2301 7th Avenue
Design Recommendation Meeting
DRB – Date: September 24, 2019
SDCI or Project Number: 3034280-LU

Why are we here?

DRB Approved Tower/Podium Erosion
(January 19, 2016)

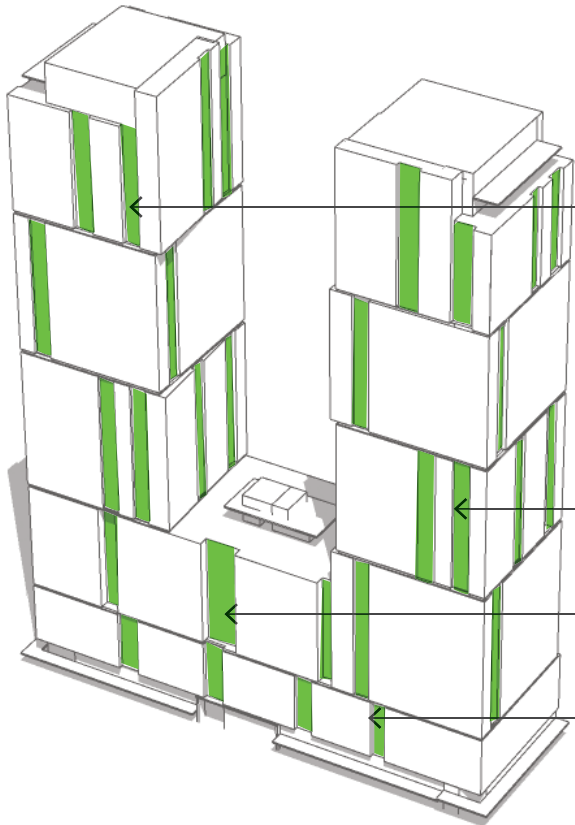
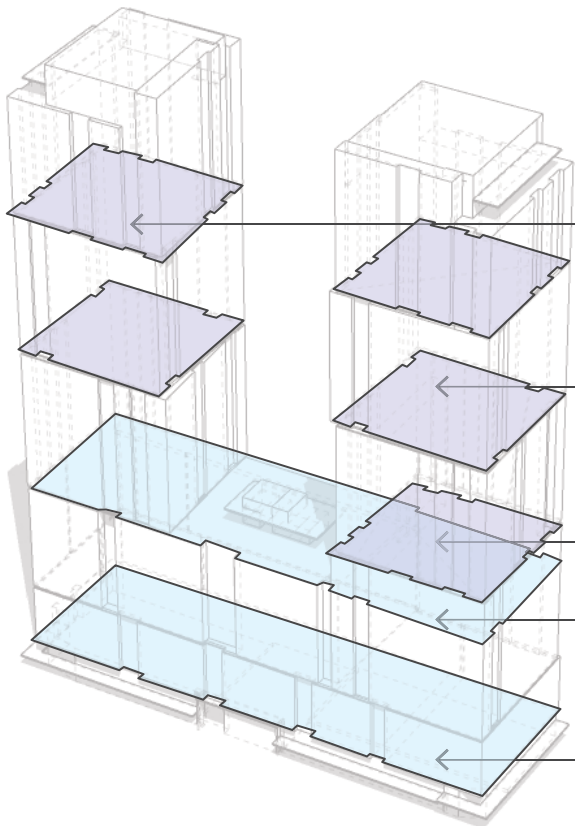
Provide design with one tower eroding podium and reaching the base.

The proposed design has evolved into essentially two podiums. The lower podium marked by a 65' datum reflects the Belltown residential and retail scale located to the west, with the second podium scale reflecting the newer and larger development scale for the Denny Triangle area. The towers then "erode" or sit at different podium heights. Rather than take the entire residential high rise facade to the ground level, the expression of inclusive neighborhood look and feel provides a unique behavior that acknowledges the surrounding presence without being intrusive. The recognition of the pedestrian presence allowed the design to evolve into a series of parts and pieces, none of which touch the ground, but rather, float above the retail plane of the street.

It is necessary for the design to lift these expressions and carefully choose which portions of the project can blend other visual identifiers. The office can have a mixture of sculpted clean glass with the book-end treatment similar to the residential tower. However, blending the visual uses further breaks away from the typical residential treatment and scale of Belltown / Denny Triangle. The inclusion of this facade treatment will help give the pedestrian a familiar scale treatment for such a vertical project.

DRB Approved Tower/Podium Modulation
(January 19, 2016)

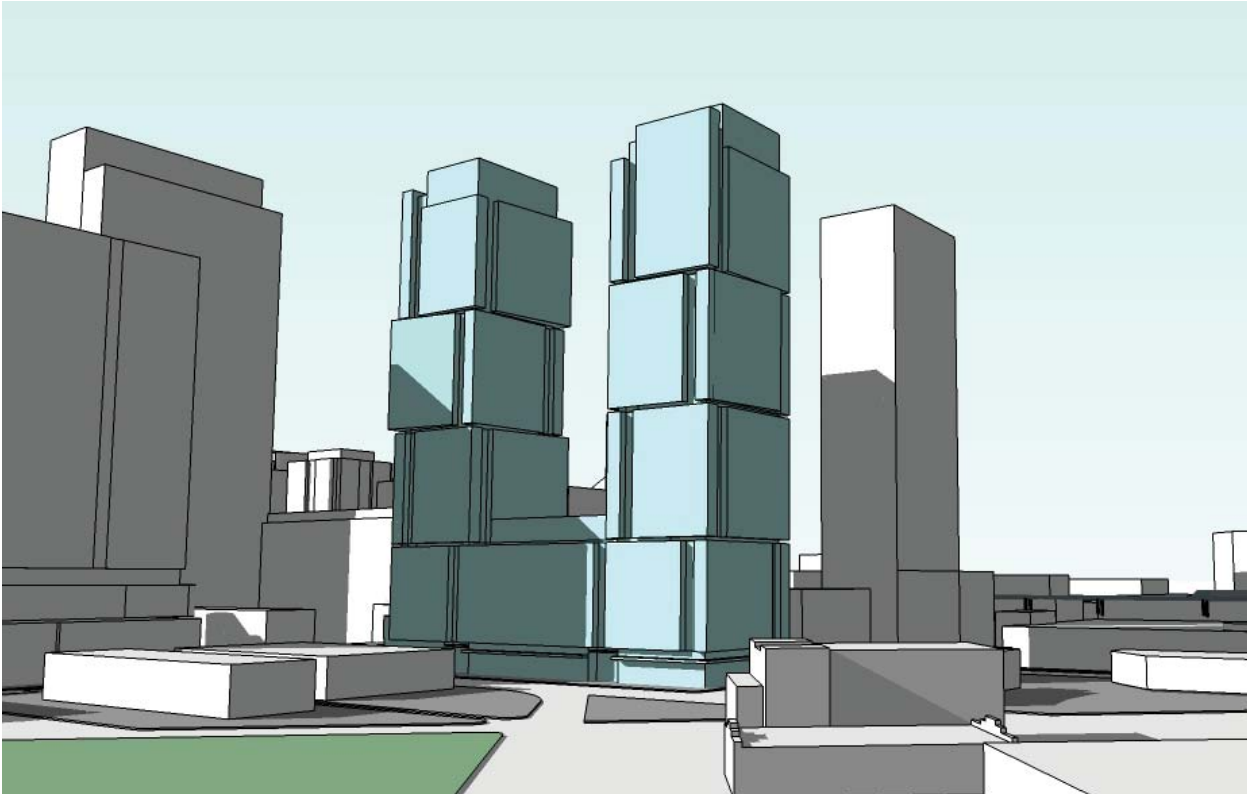
Encouraged a design with panelized modules, as it would allow for a very interesting design with differing materials. Use the reveals between the modules to bring the tower down to the base.

The playful nature of the tower caps in the previous EDG option 1 have been expressed in the proposed design. Two of the four parapet sections continue up past the L42 amenity levels and become mechanical penthouse screens. The other two sections stop at L42 providing outdoor amenity space and bioretention planters. With the additional height provided by the HALA/MHA incentive program, we were able to re-proportioned the cube sizes making them appear more equal in size and character than the DRB#1 design. These playful caps ultimately integrate multiple program needs including indoor and outdoor amenity, elevator overruns and mechanical equipment.

In response to the DRB comments regarding the Tower Caps, the design team worked with the planner to resolve the imbalance between the last two cubes of both towers by adding parapet height. With the **Proposed Design**, we do not need to raise the parapet heights. We are able to resolve that imbalance much easier with the utilization of the extra MHA height. With the extra 40', the residential tower cubes and corresponding tops holistically resolve the DRB's original concerns better than the previous design.

Asymetrical Sitting
EDG Option 2

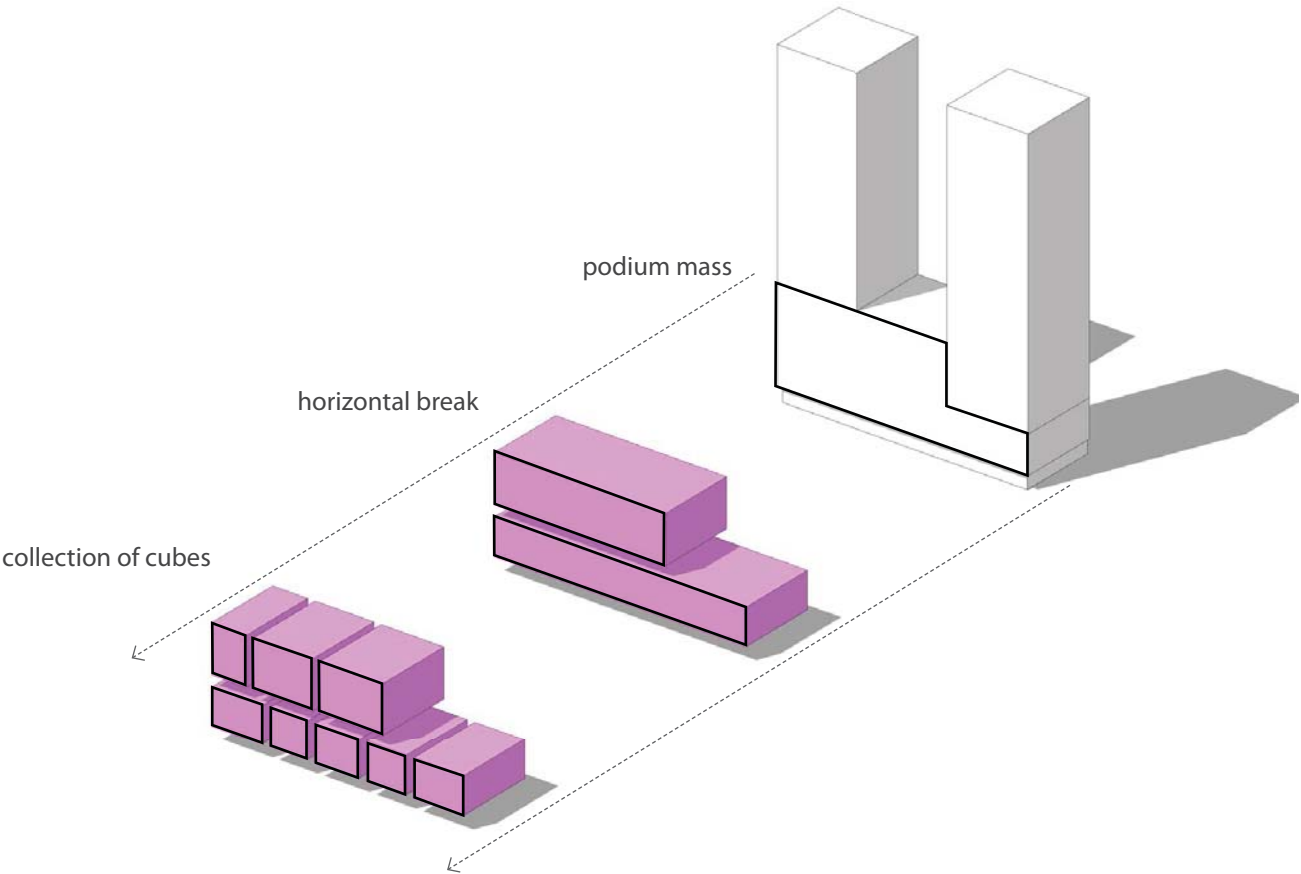
Provide a design with one of the towers eroding the podium to break up its massing as shown in Option 2

The podium will slide down and sit between the grounded tower and the glass base cubes. The idea that these ice cubes will trickle down and reach the base is emphasized with this design. The cubes break apart, pull apart, and sit individually as the building blocks of the project above. These blocks are sandwiched between a condition typical to the surrounding neighborhood datum which gives the design a unique playfulness and neighborhood familiarity.

DRB Approved the Rescission of Open Space Stepping Guidance (January 19, 2016)

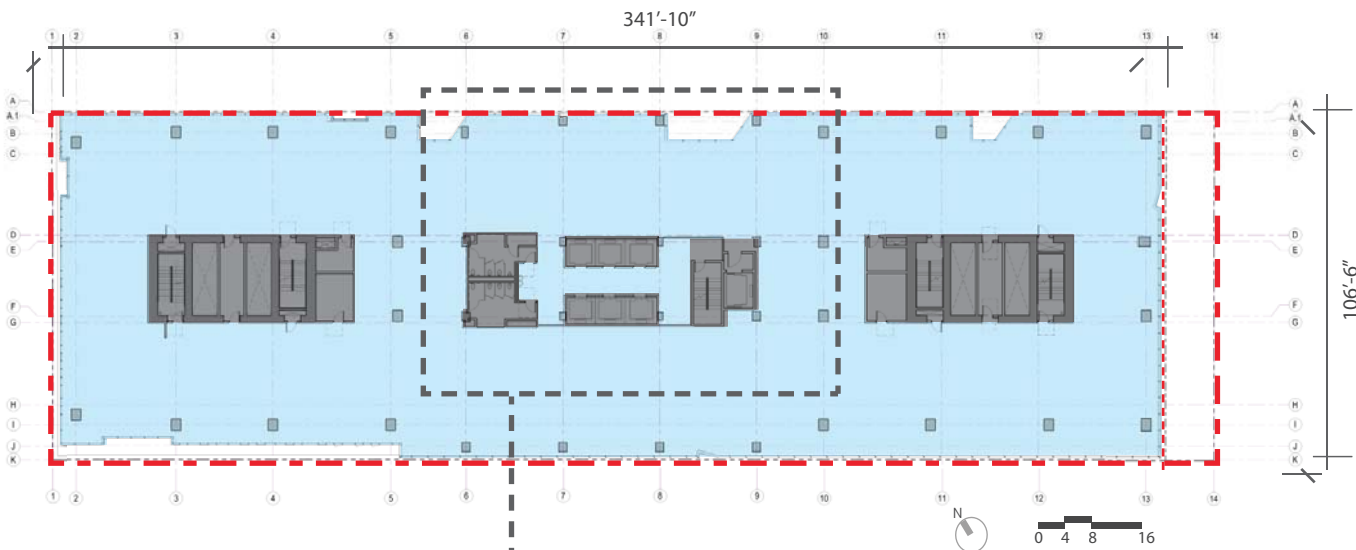
Podium / open space stepping down at top.

The proposed step of the previous design options did not include a dedicated office core. Once this was added, the step was no longer feasible considering the impact on the depth of the office space and its leasing flexibility along 7th Avenue. In addition, the step occurs at the 10th floor of the project, reducing the positive impact of the recess at the pedestrian level. Instead of utilizing the prescribed modulation approach, we propose that the podium's character is positively enhanced by dispersing the prescribed modulated area through out 7th Avenue's facade, bringing a large percentage of it lower on the facade, actually making it more impactful at the pedestrian level.

Leasing depths not including corridor would reduce to 23'-0" under code compliance, where as leasing depths would be 30'-0" not including corridor under proposed departure.

**DRB Approved Podium
Facade Design**
w/ conditions (January 19, 2016)

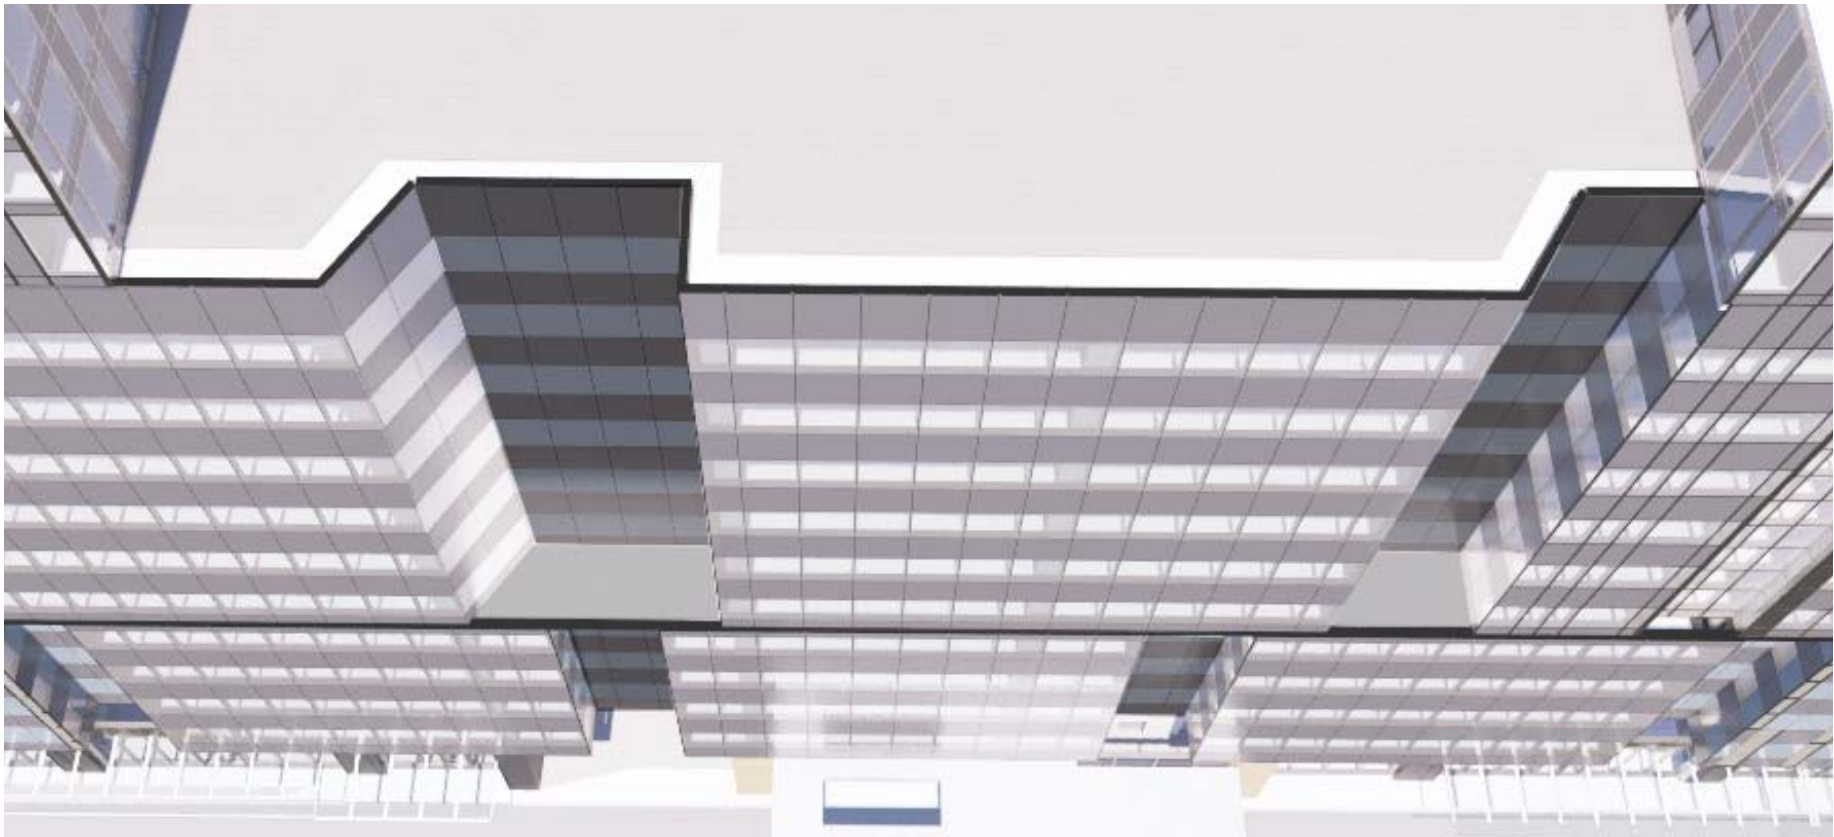
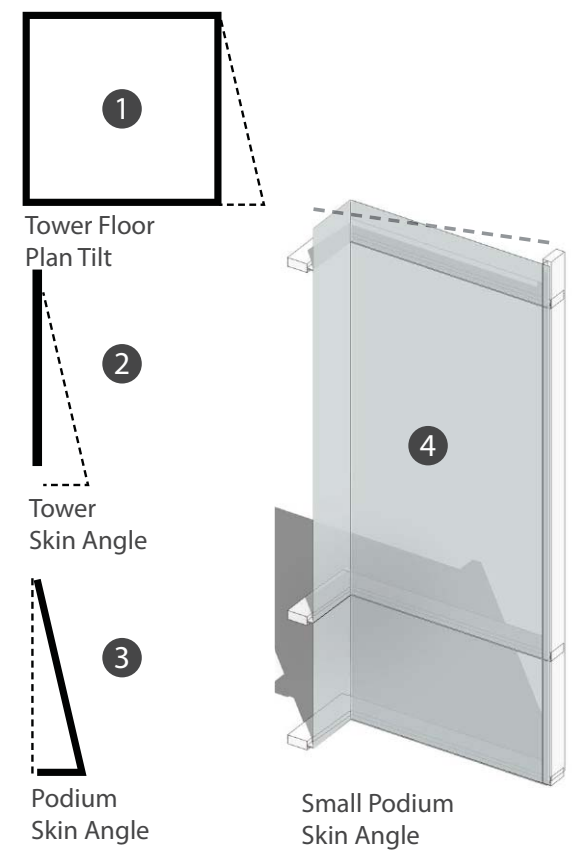
Study the facade treatment of the retail space and above grade parking levels. Consider using the retail facade treatment at the parking levels.

Levels 2 through 5 no longer include parking above grade or residential uses. These levels have been converted to office, therefore utilizing office facade language in the current concept.

The office components occurring within the podium will bring the Belltown neighborhood character as a unique engaged accent for the podium. This will keep the pedestrian experience similar to smaller scale Belltown projects while acknowledging the project area above.

DRB Approved Podium Facade Treatment
w/ conditions (January 19, 2016)

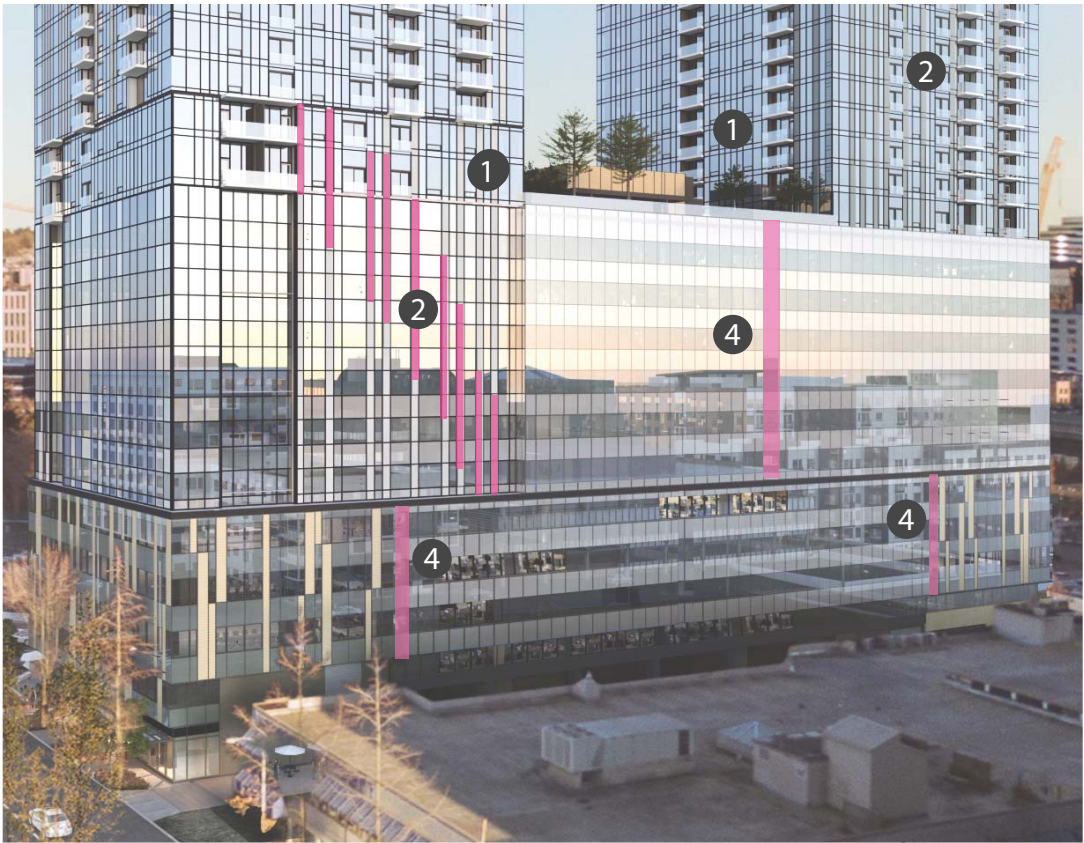
Consider panelized modules, different materials and reveals to bring tower to base.

As the facade treatment is carried below to the lower office levels, a similar facade component is utilized. The interior cubes of the podium levels will also be treated similar to the upper glass cubes

The book-ends of the lower office components will emphasize similar character of Belltown and bring the large project to the pedestrian scale. These blocks will break away from the consistent language to give the towers and podium a strong base, similar to the scale of the neighborhood.

Battery Street Corner

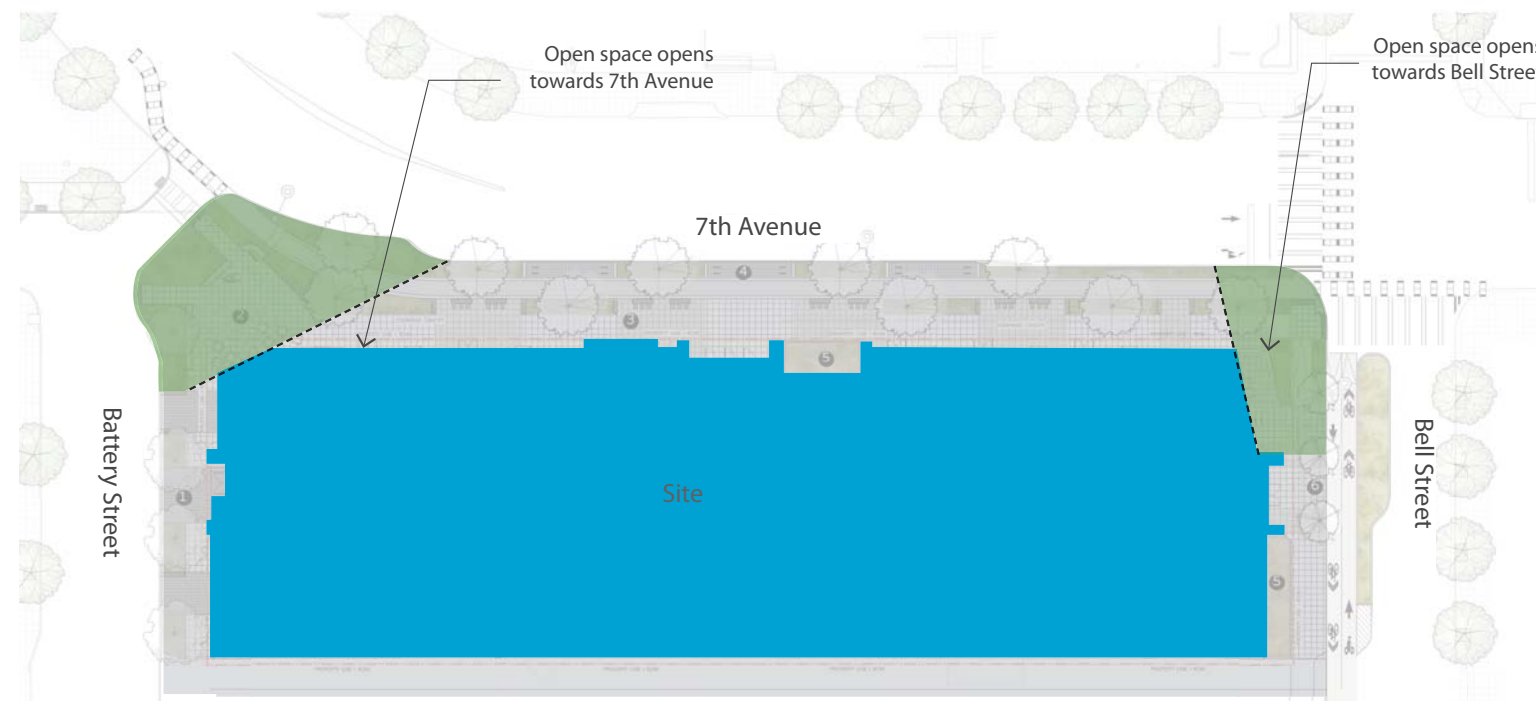
Push back or cant podium facade at grade along Bell Street similar to Option 3.

The facade along Bell Street directs the pedestrian with a playful angle opening up to 7th Avenue. The presence of angles within the project's design give an opportunity for a gentle plan accent as the street retail tucks under the podium and project above.

To make the concept stronger, and to emphasize the pinwheel design effect, an angular plan design was introduced on the 7th Avenue and Battery Street corner. Rather than tilt the plan down Battery Street, the angle largely occurs on 7th Avenue. This will emphasize the idea of an angle pinwheeling in plan, and will give an asymmetrical concept to the retail base.

In plan, the emphasis is to engage not only the streets, but the corner as well. Engaging both corners allows these Green Streets to connect to one another and complete the treatment on all 3 major facades.

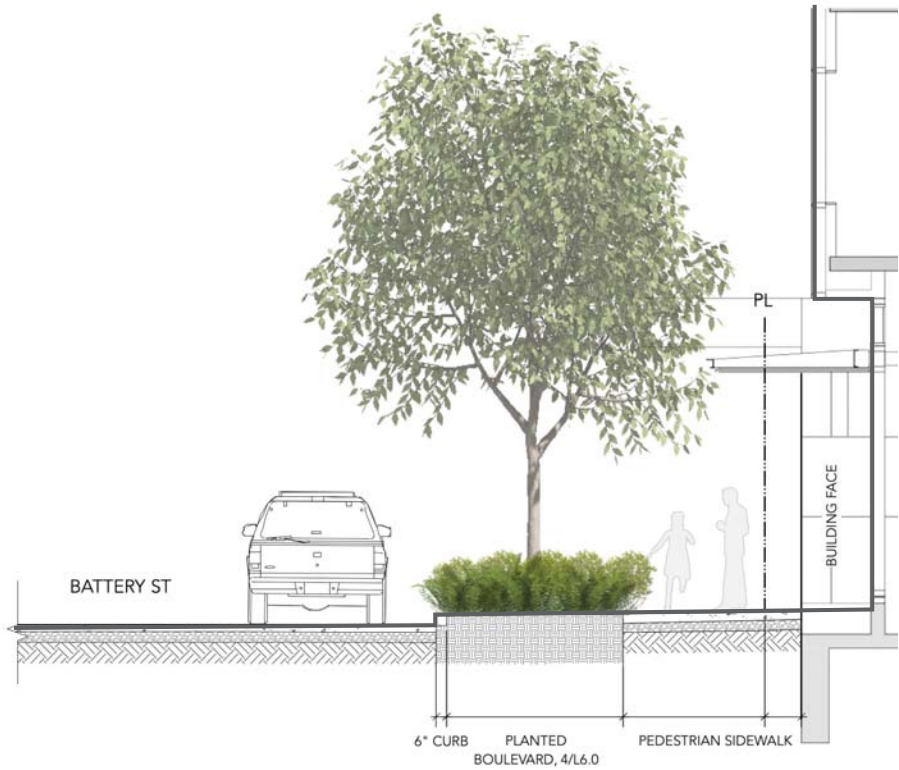
Activate the retail space along Battery Street with the design of the street.

The facade along Battery Street directs the pedestrian with a playful angle opening up to 7th Avenue. The combination of residential lobby, retail corner, robust landscape, and corner plaza will have extensive activity through out the day.
